**DATE:** December 8, 2014  
**TO:** Planning Commission  
**FROM:** Rich Sucre, Planner/Preservation Technical Specialist  
**RE:** 1140 Folsom Street Update (Case No. 2013.0986CX)

On November 20, 2014, the Planning Commission reviewed the proposed project at 1140 Folsom Street (Case No. 2013.0986CX), which included a request for a Large Project Authorization, Conditional Use Authorization and a Planned Unit Development.

The Planning Commission continued these items to the public hearing on December 18, 2014, and requested the following:

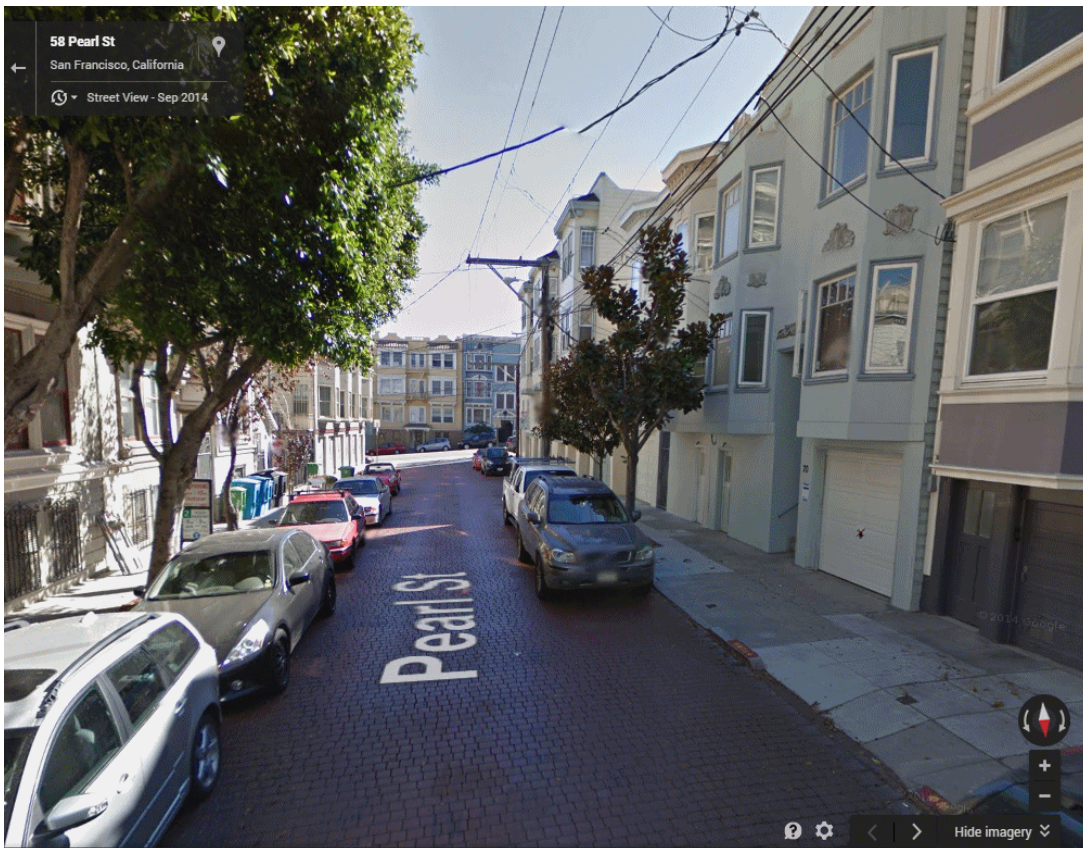
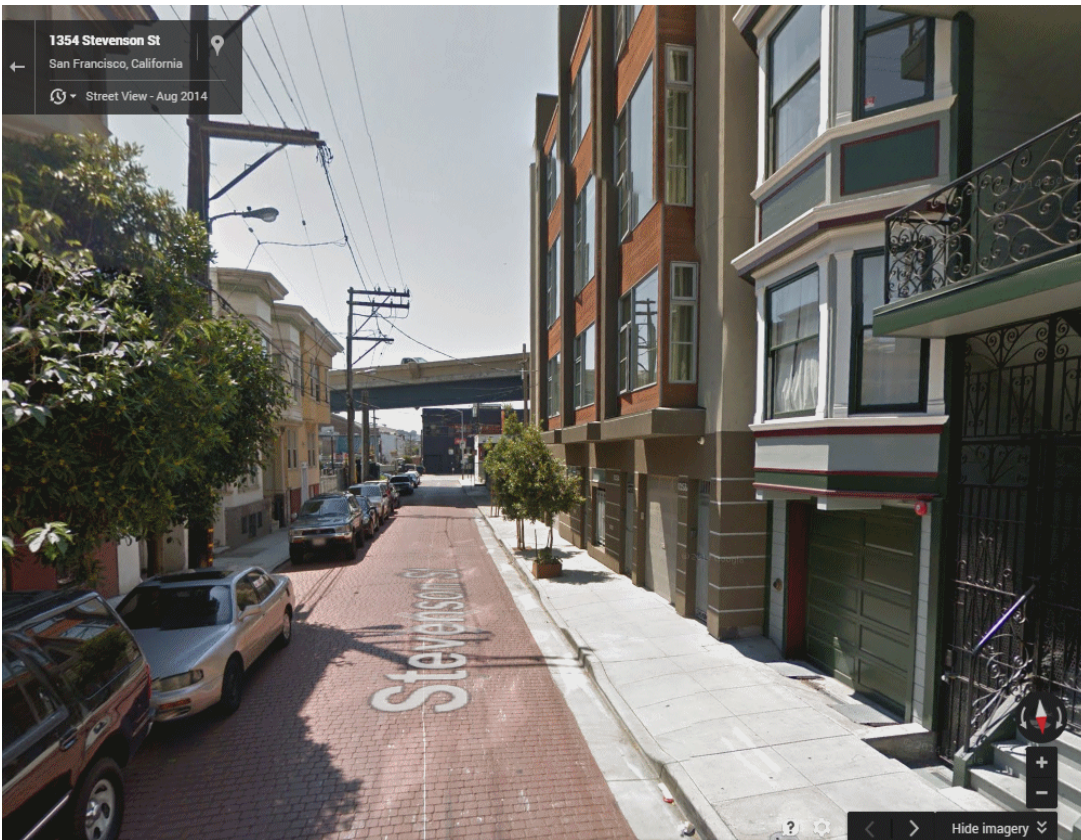
See the accompanying PDF for a sketch of possible redesign of the area. The drawing is based on tracing the Site Survey by BAR and adjusting for measurements of sidewalk and street dimensions. The “Right of Way” on Rausch is 51'. In the narrow, northern part, that 51' breaks down as 13' sidewalk + 25' pavement + 13' sidewalk. We call this 'the bottleneck' or 'the notch'. In the wide part, the 51' breaks down as 13' sidewalk (west) + 30' pavement + 8' sidewalk (east.) At the Folsom entrance, the slanted curb on the west side of Rausch increases the drivable pavement width to 35', creating a fast entrance for vehicles from Folsom, an inviting funnel mouth.

1. Add 2 spaces on Folsom along the edge of the plaza (hourly parking).
2. Lose 2 residential spaces at the Folsom end of Rausch (one on each side of Rausch, at the corner), but add about 6 spaces in the former yellow zones and curb cuts on the east side of Rausch, for a net gain of about 4 spaces.

**The plaza will protect pedestrian safety along Folsom St.**, because of the raised crossing, bollards, and channelized traffic. For a discussion of raised crosswalks, see the SF Better Streets Policy, p. 105: [http://www.sf-planning.org/ftp/BetterStreets/docs/Draft\\_BSP\\_5\\_Street\\_Designs.pdf](http://www.sf-planning.org/ftp/BetterStreets/docs/Draft_BSP_5_Street_Designs.pdf). This is why the drawing shows the pink areas at an angle, where cars enter and exit the raised crossing, so that incoming traffic from Folsom meets the bump squarely, as shown by the gray arrow. This has the additional advantage of offsetting pedestrian flow along the Folsom sidewalk, which has safety benefits by forcing pedestrians to pay attention at the crossing. See p. 124 of the BSP.

The drivable space across the plaza in this drawing is at least 12' wide (more with removable bollards). If you're concerned about fire trucks, take a look at this view of Sanchez St. in the Duboce Triangle area. Right next to a fire station you can see a street island with a tree, forming narrow (probably less than 12') channels on each side:

In the sketch, the light green area labeled "Corner set-back" is a suggestion to improve the feel of the plaza and to add an iconic design to the building. It may be a long-shot that the developers would want to do this, but it would add a little space to the plaza, open up sight lines, and de-congest foot traffic around that corner (which we hope will be a busy cafe).

It might also be a way to address one of the complaints of the Planning Commission that the earlier building design was dull and not distinctive. The wall space (perhaps 10' or 15' wide and several stories high) above that diagonal could be distinctive in some way. The windows could be shaped differently, there could be small balconies, there could be a clock on the top floor (ok, that's corny), or something else. People approaching the building would see that angled facade (light would reflect differently off of it compared to the adjoining non-angled surfaces) and get the idea that this isn't just a row of housing blocks. There's a neighborhood here, and this plaza is a focal point of it.

FIGURE 3 – SITE PLAN

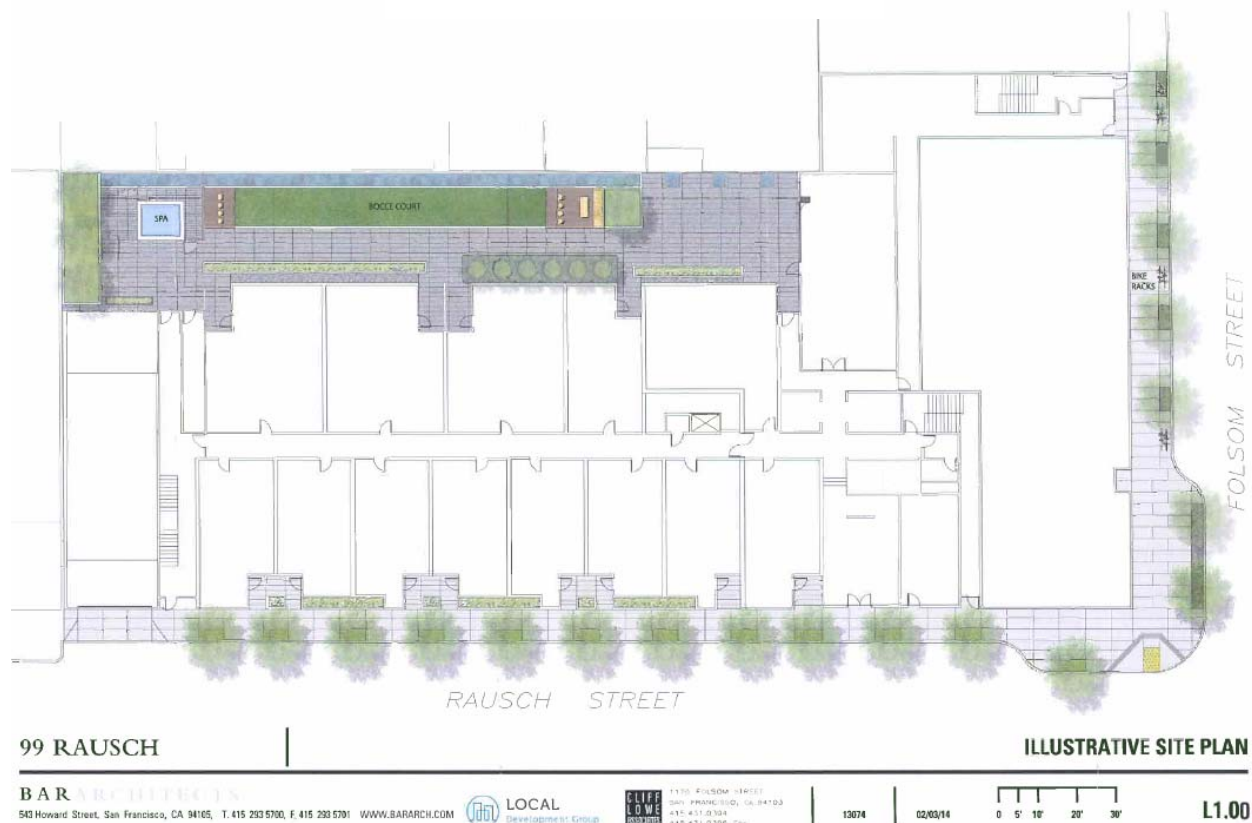
As shown in **Figure 3 – Site Plan**, the parking garage would be accessed through a ramp on Rausch Street at the northwest corner of the property.
